REV	ECO	DATE	APV		THIS PRINT IS THE PROPERTY OF ADC. IT SHALL NOT BE COPIED WITHOUT PERMISSION.				TITLE			
					MATERIAL				SYSTEM I/C			
					FINISH				5KW S.S. UHF XMTR (1278-1000)			
DWN	PJK	7/18/96			CHK	RE	7/19/96		DWG. NO.	1278-8000	REV	
REL	RE	7/19/96							SCALE 1=1	SHEET	1 OF 1

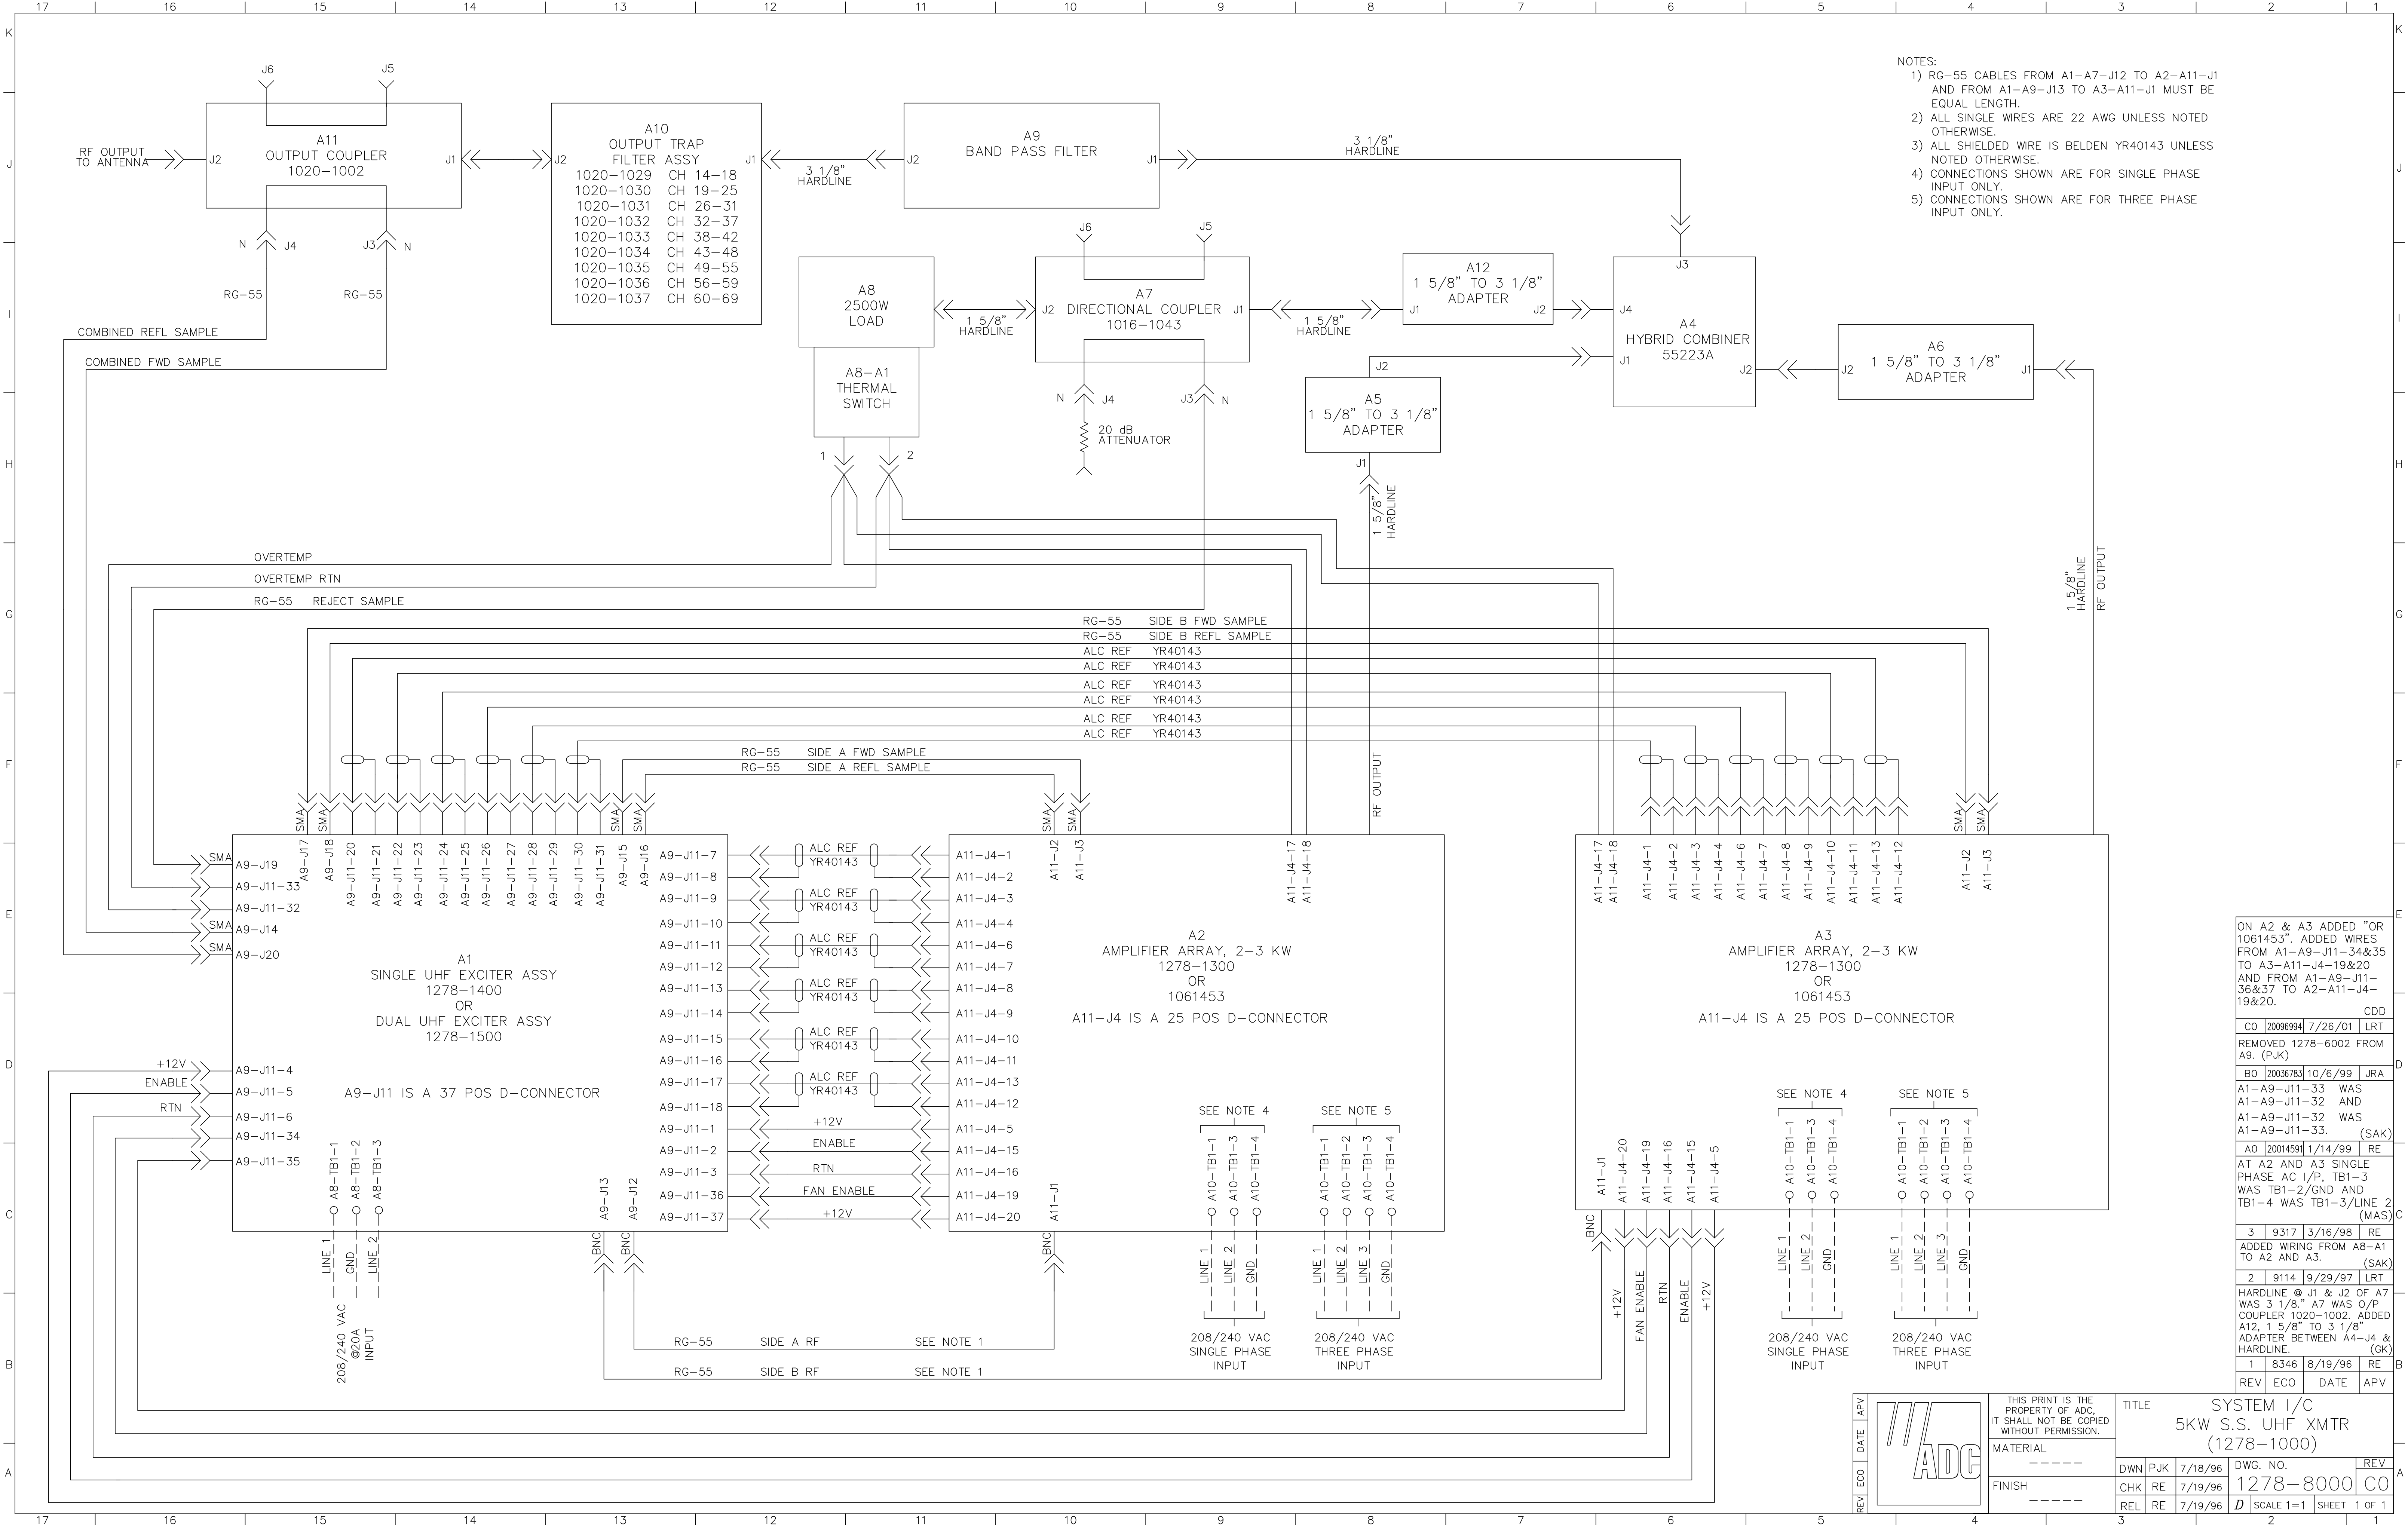
ON A2 & A3 ADDED "OR 1061453". ADDED WIRES FROM A1-A9-J11-34&35 TO A3-A11-J4-19&20 AND FROM A1-A9-J11-36&37 TO A2-A11-J4-19&20.				CDD
CO	20086994	7/26/01	LRT	
REMOVED 1278-6002 FROM A9. (PJK)				
BO	20036783	10/6/99	JRA	
A1-A9-J11-33 WAS A1-A9-J11-32 AND A1-A9-J11-32 WAS A1-A9-J11-33. (SAK)				
AO	20014591	1/14/99	RE	
AT A2 AND A3 SINGLE PHASE AC I/P, TB1-3 WAS TB1-2/GND AND TB1-4 WAS TB1-3/LINE 2 (MAS)				
3	9317	3/16/98	RE	
ADDED WIRING FROM A8-A1 TO A2 AND A3. (SAK)				
2	9114	9/29/97	LRT	
HARDLINE @ J1 & J2 OF A7 WAS 3 1/8". A7 WAS O/P COUPLER 1020-1002. ADDED A12, 1 5/8" TO 3 1/8" ADAPTER BETWEEN A4-J4 & HARDLINE. (GK)				
1	8346	8/19/96	RE	
REV	ECO	DATE	APV
